Braidwood Station, Units 1 and 2
Facility Operating License Nos. NPF-72 and NPF-77
NRC Docket Nos. STN 50-456 and STN 50-457

Byron Station, Units 1 and 2
Facility Operating License Nos. NPF-37 and NPF-66
NRC Docket Nos. STN 50-454 and STN 50-455

Subject: Supplemental Information Related to License Amendment Request Regarding
Measurement Uncertainty Recapture Power Uprate

**Revised Pages to MUR Power Uprate LAR,
Attachment 5a, "Braidwood and Byron Stations
Steam Generator Tube Rupture Analysis Report"**

**Figure II-1 Pressurizer Level –
Unit 1 Margin to Overfill Analysis**

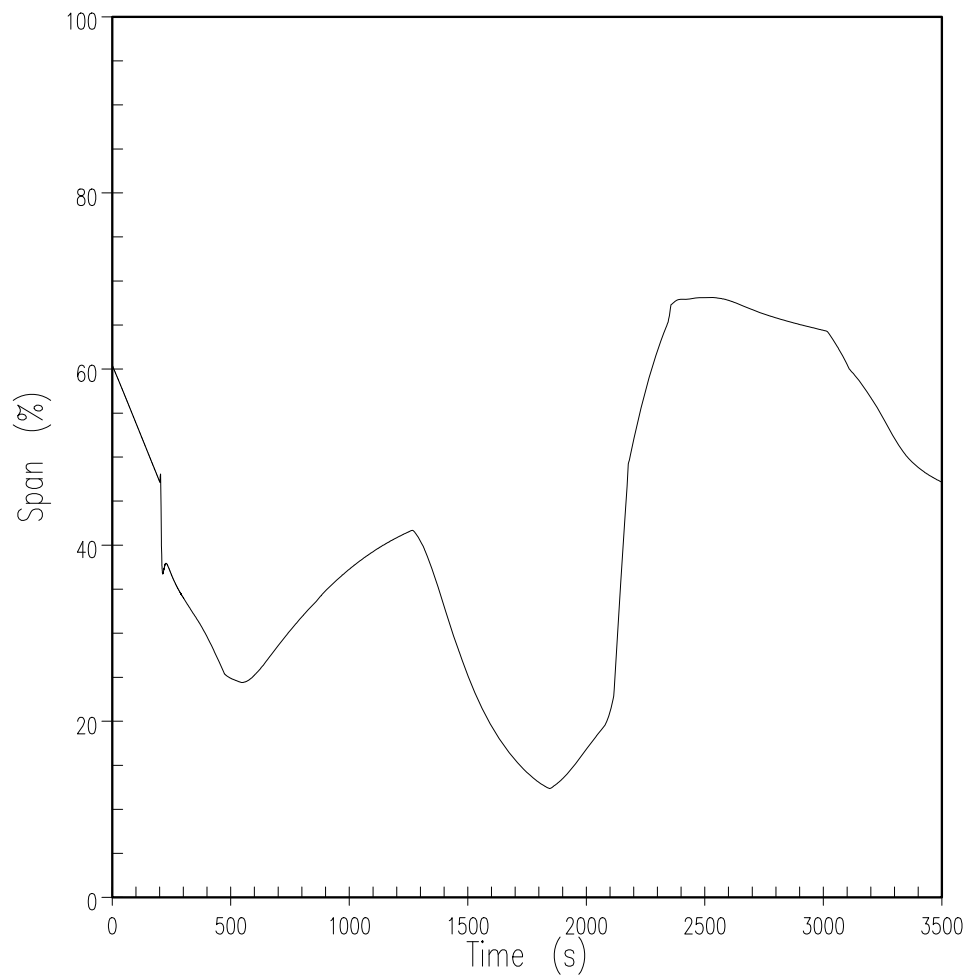
After isolation of the ruptured SG, a 3-minute operator action time was assumed prior to initiating the cooldown. Due to the assumed failure of one of the intact SG PORVs to open only two intact SGs were credited for the cooldown. It was therefore assumed that the PORVs on two intact SGs were opened for the RCS cooldown at 21 minutes after the start of the event, as shown in Figure II-6 (Unit 1) and Figure II-12 (Unit 2). The cooldown was continued until the cooldown termination temperature obtained from EOPs was reached. When this condition was satisfied the operator closed the PORVs to terminate the cooldown. This cooldown ensured that there would be adequate subcooling in the RCS after the subsequent depressurization of the RCS to the ruptured SG pressure. The reduction in the intact SG pressure required to accomplish the cooldown is shown in Figure II-1 (Unit 1) and Figure II-8 (Unit 2). The pressurizer level and RCS pressure also decreased during this cooldown process due to shrinkage of the RCS as shown in Figure II-1 and Figure II-2 (Unit 1) and Figure II-7 and Figure II-8 (Unit 2).

After termination of the cooldown, a 4-minute operator action time was assumed prior to the RCS depressurization. In these analyses, the RCS depressurization was terminated when the RCS pressure was reduced to less than the ruptured SG pressure and the pressurizer level was above the required value, since there was adequate subcooling margin and the high pressurizer level setpoint was not reached. The RCS depressurization is shown in Figure II-2 (Unit 1) and Figure II-8 (Unit 2). The depressurization reduced the break flow as shown in Figure II-3 (Unit 1) and Figure II-9 (Unit 2) and increased SI flow to refill the pressurizer, as shown in Figure II-1 (Unit 1) and Figure II-7 (Unit 2).

**Figure II-2 RCS and Secondary Pressures –
Unit 1 Margin to Overfill Analysis**

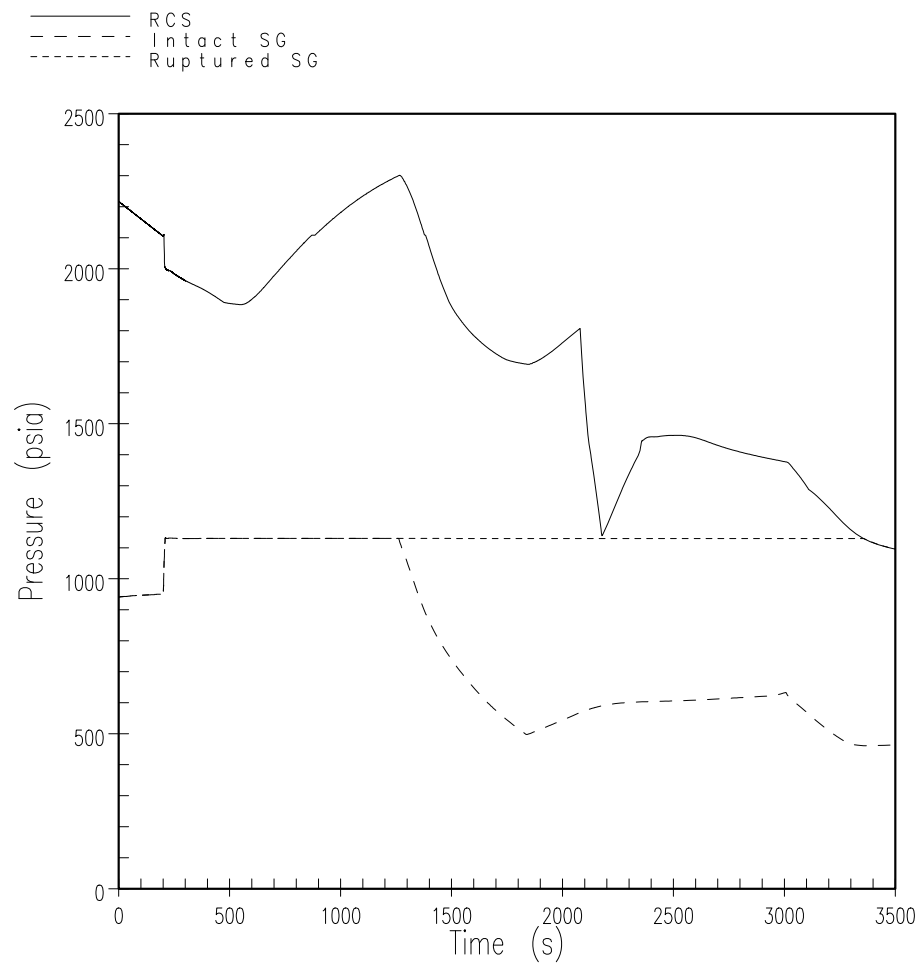
After termination of the depressurization, a 3-minute operator action time was assumed prior to SI termination. The SI flow was terminated at this time since the requirements for SI termination were satisfied. (RCS subcooling was greater than the required allowance for subcooling uncertainty, minimum AFW flow was available or at least one intact SG level was in the narrow range, the RCS pressure was stable or increasing, and the pressurizer level was greater than the required value.) After SI termination the RCS pressure began to decrease as shown in Figure II-2 (Unit 1) and Figure II-8 (Unit 2).

**Figure II-3 Primary to Secondary Break Flow –
Unit 1 Margin to Overfill Analysis**

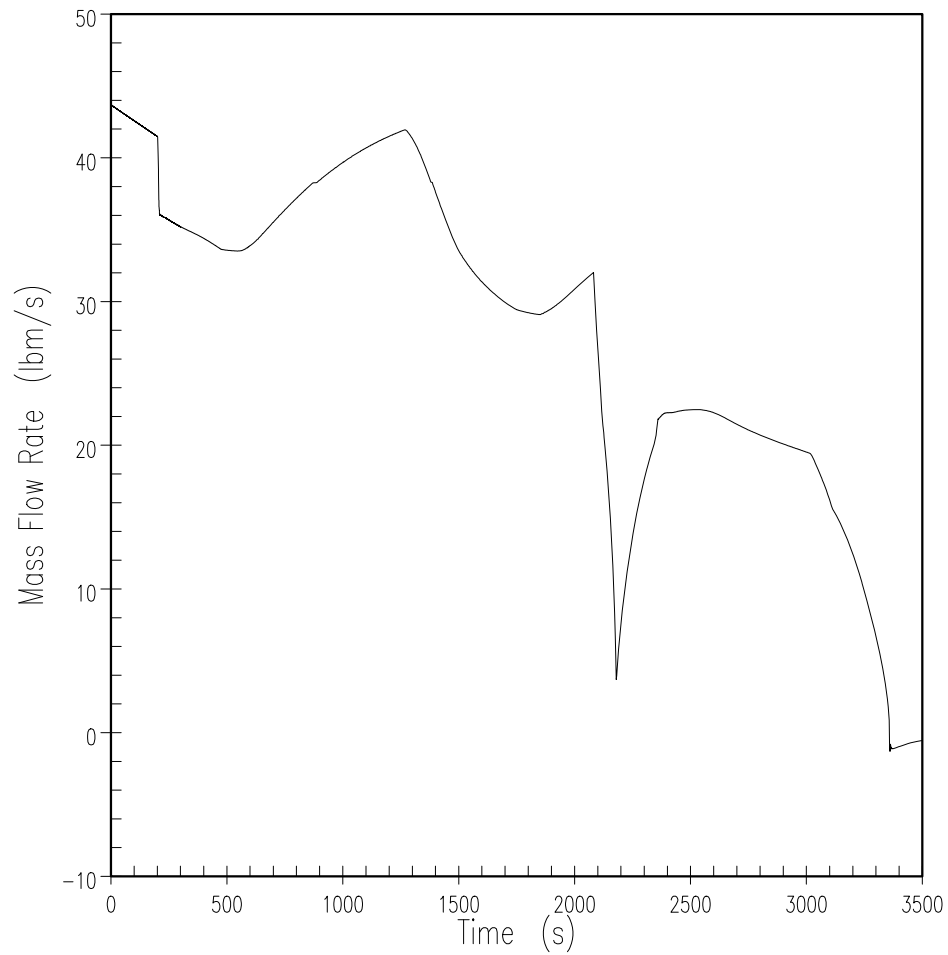
The primary to secondary break flow rate throughout the recovery operations is presented in Figure II-3 (Unit 1) and Figure II-9 (Unit 2). The ruptured SG fluid mass is shown in Figure II-4 (Unit 1) and Figure II-10 (Unit 2). The water volume in the ruptured SG is presented as a function of time in Figure II-5 (Unit 1) and Figure II-11 (Unit 2). The peak ruptured SG water volume for Unit 1 is 5068 ft³ resulting in 54 ft³ of margin to overfill. The peak ruptured SG water volume for Unit 2 is 5685 ft³ resulting in 270 ft³ of margin to overfill. Therefore, it is concluded that overfill of the ruptured SG will not occur for a design basis SGTR for Byron and Braidwood Units 1 and 2.
